# Armada Way LTN1/20 Review

Plymouth City Council

The proposed cycling facilities have been designed by Studio Agora Architects and this technical note will assess the cycle facilities against the design recommendations in LTN 1/20.

**Figure 1: Extract of proposed improvements along Armada Way**

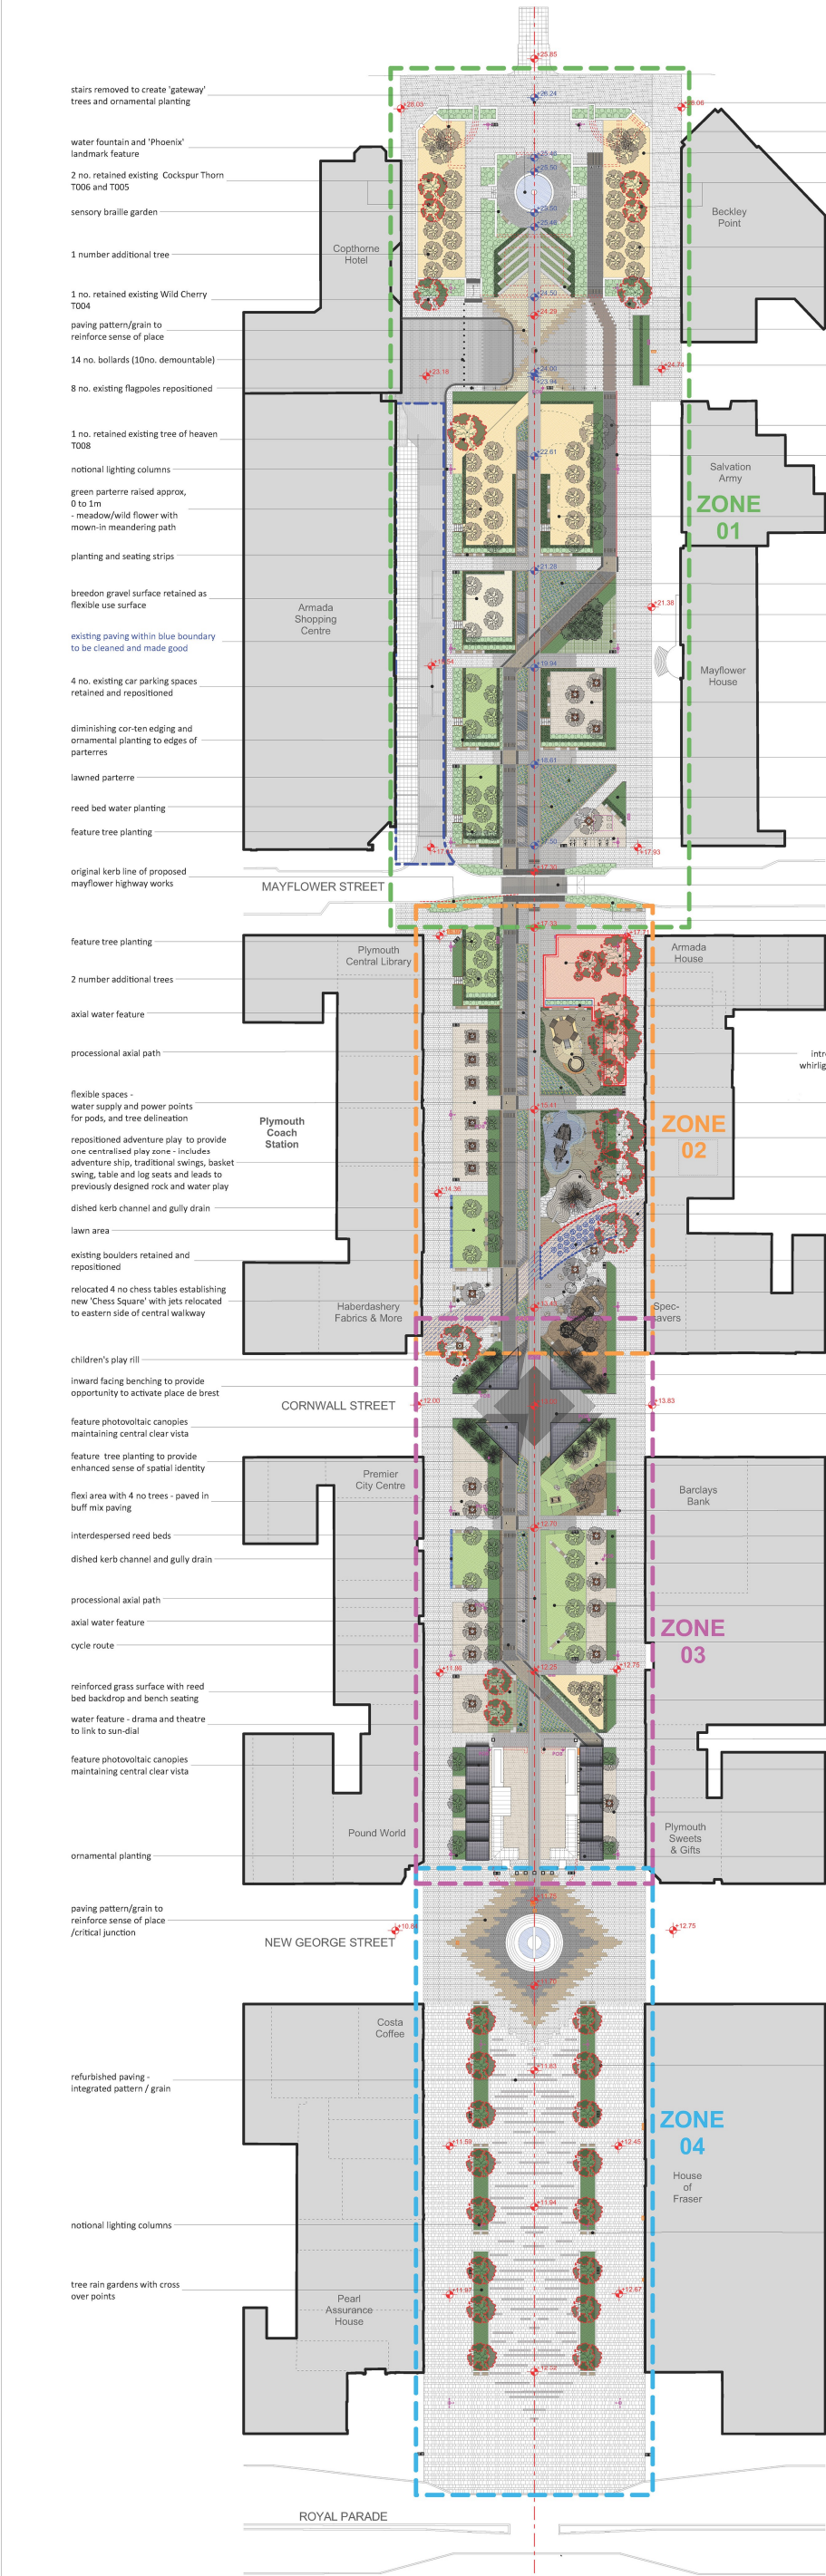
The proposal shows a north-south cycleway that is integrated within the scheme works and differentiated from adjacent surfaces using a designated paving pattern. There are some sections of the cycleway that intersect with pedestrian facilities, which are highlighted using buff paving and in paving flag signage. At these locations cyclists will be required to give pedestrians priority. The cycleway will be bordered by a mix of flush kerbs, tactile paving, grass verges and a water rill feature. Where vertical features are present, the cycleway will be widened to allow additional space.
